Responses to RFIs regarding the RFP for Site/ Civil Engineering Services for 26 Monroe St.

Date: 7/22/2026

Project Name: 26 Monroe
Project Sponsor: Sound Communities, Inc.
Project Site: 24 ½ and 26 Monroe Street, Norwalk, CT 06854

PROPERTY & TOPOGRAPHIC SURVEY

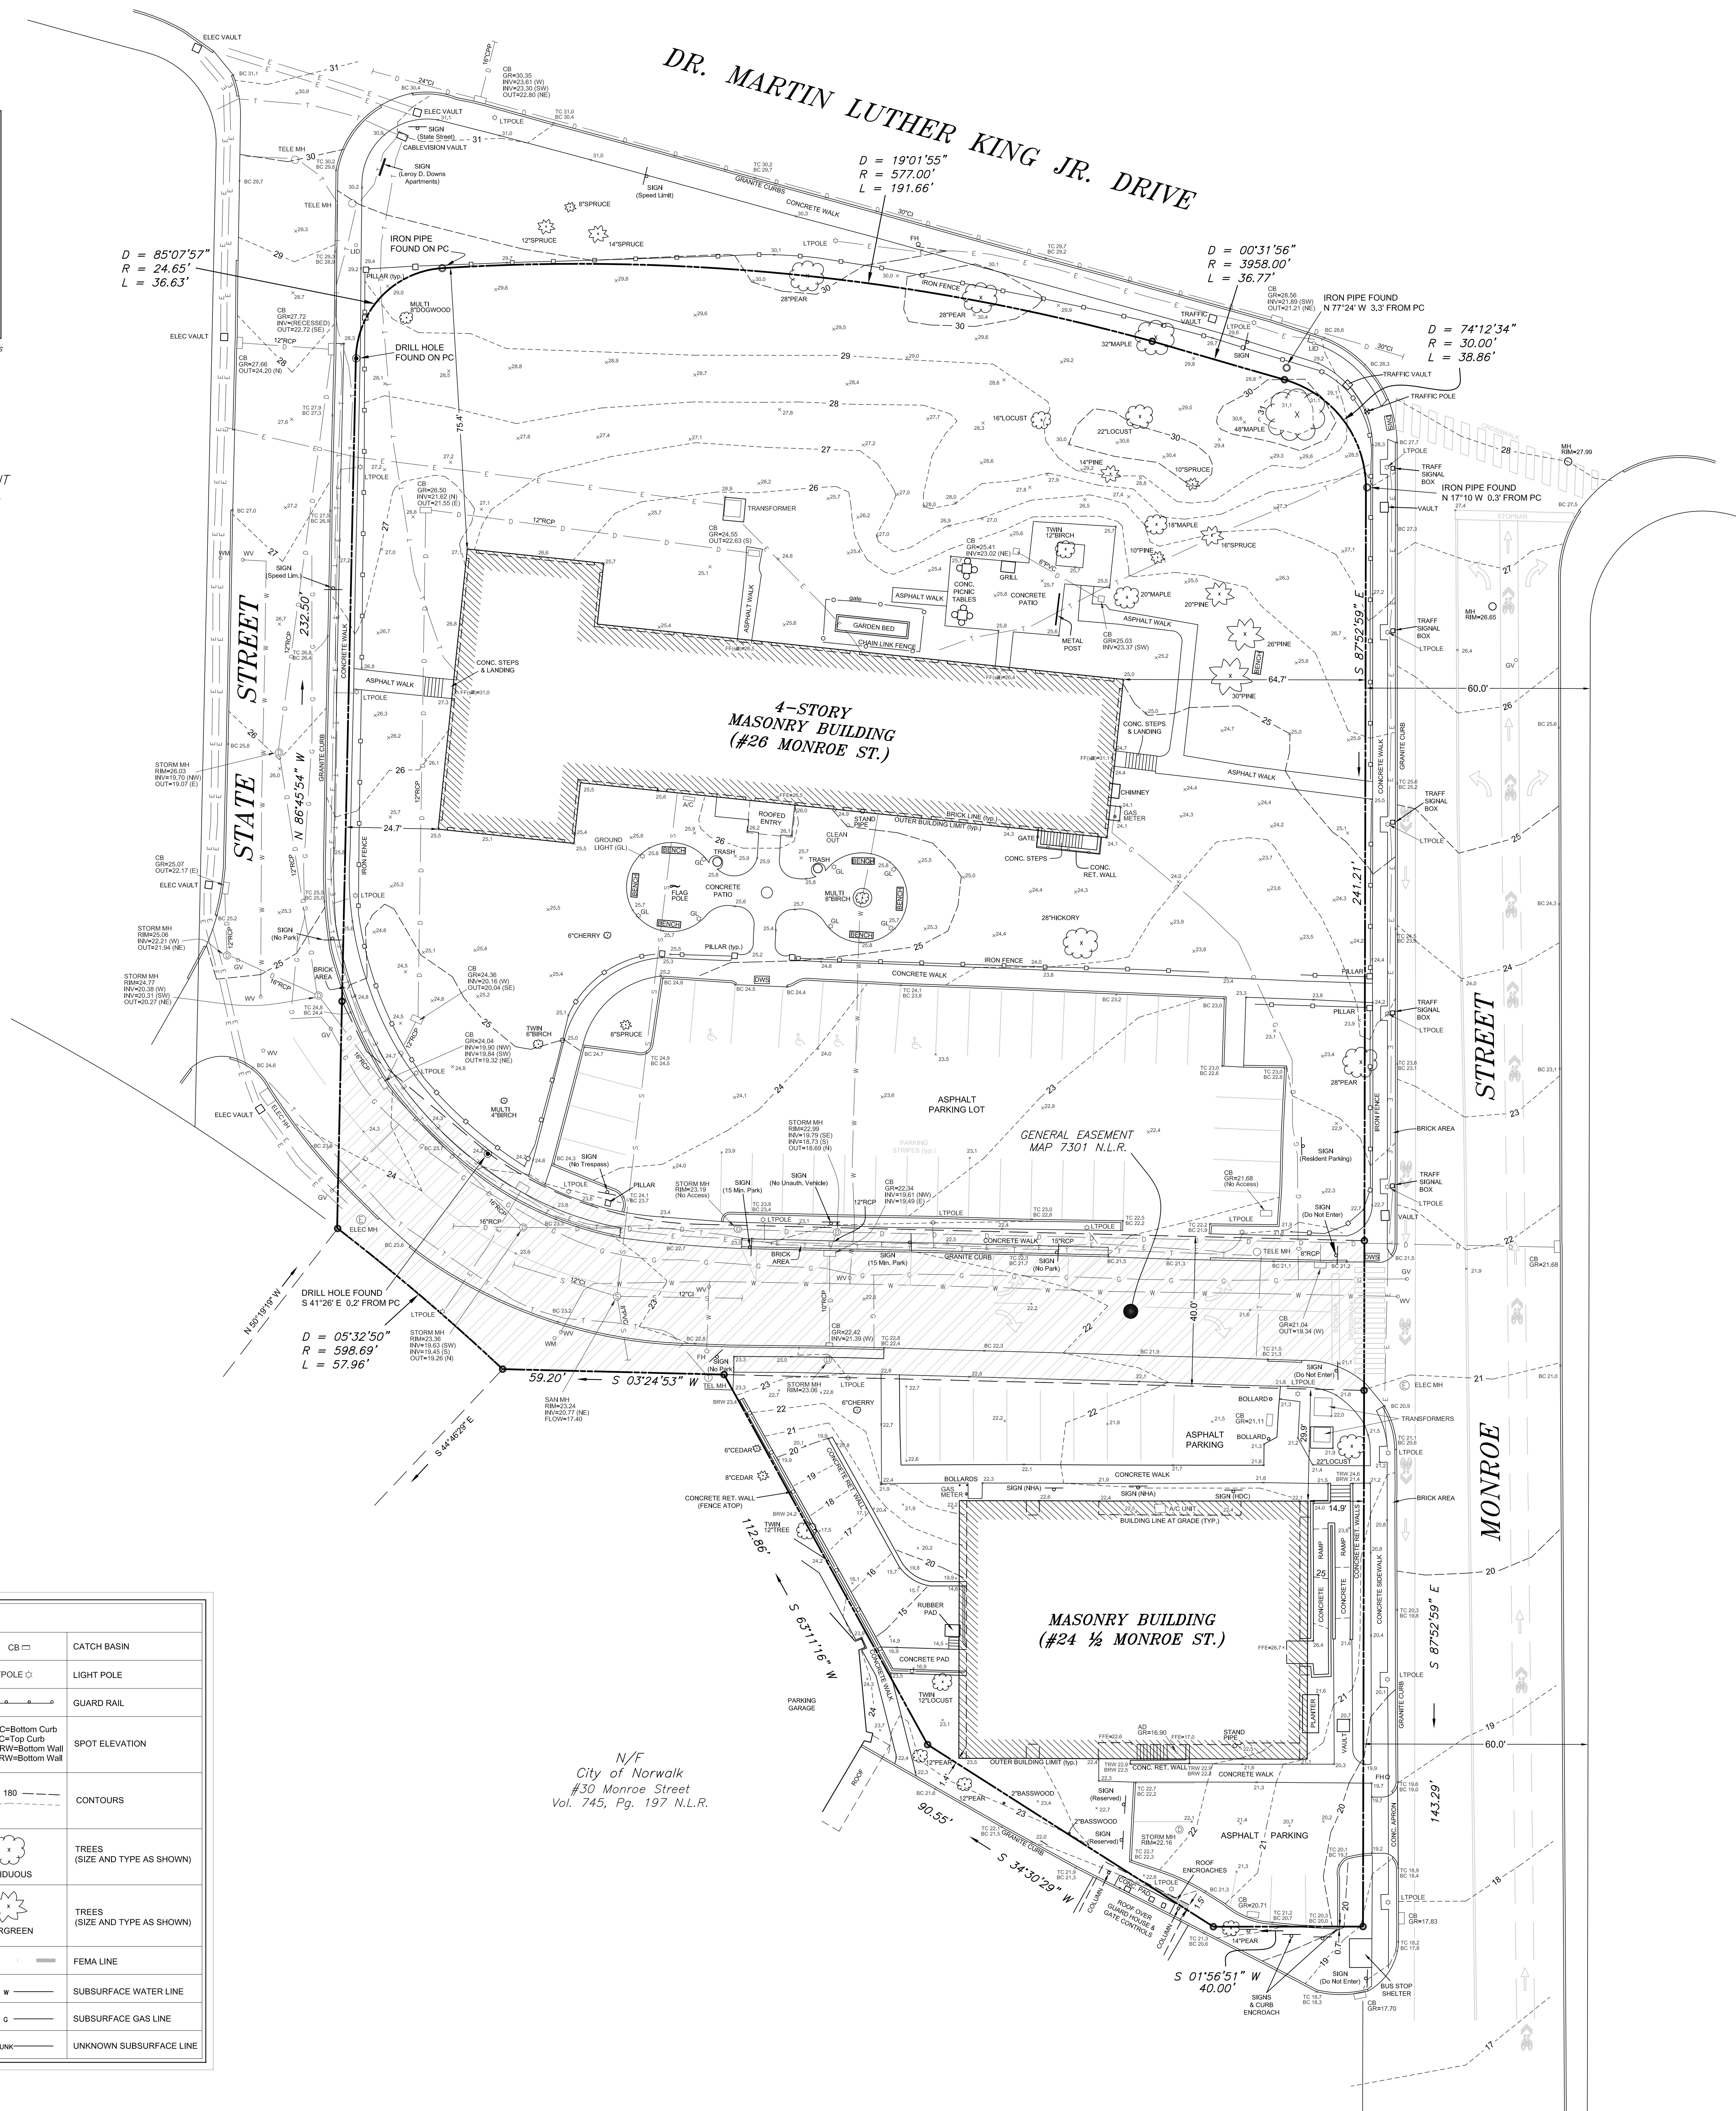
21. Please confirm that an AutoCAD version of the Property & Topographic Survey by Redniss & Mead will be available for use by the selected firm.

- **Response:** An AutoCAD survey will be requested from Redniss & Mead and made available to the selected firm.
